**9 September 2012**

**Part 3A Approval 10\_0133 - Newcastle Gas Storage Project**

**Section 75W Application – Washing Out of Concrete Trucks**

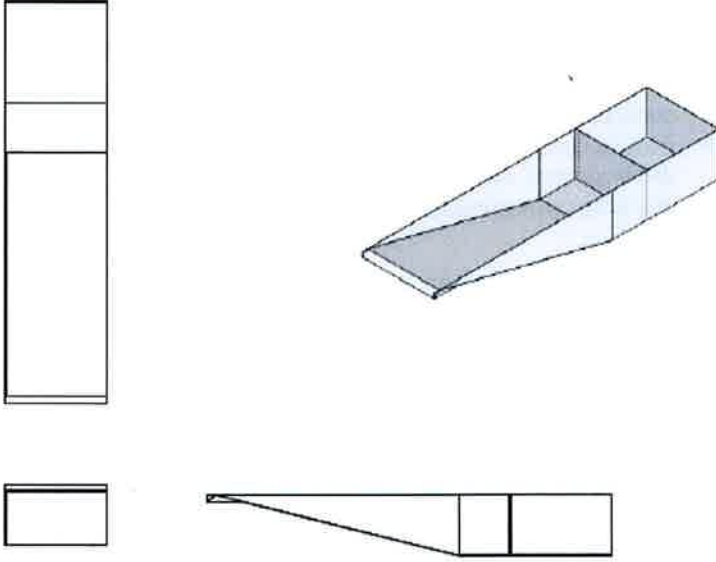
The volume of the CWA will be 120 per cent of the estimated volume of waste for the largest concrete pour on site. The

washout area will be concrete lined to ensure that wash water and the concrete particles does not get into the ground water . The edge of the washout area will be raised to stop surface water runoff getting in. The washout will not be covered so it will have to be pumped out after rain events when it's not being used. Upstream runoff will be diverted around the washout area.

Below is a sketch showing the indicative design of the proposed washout area that will conform to the conditions in the Waste Management Subplan.
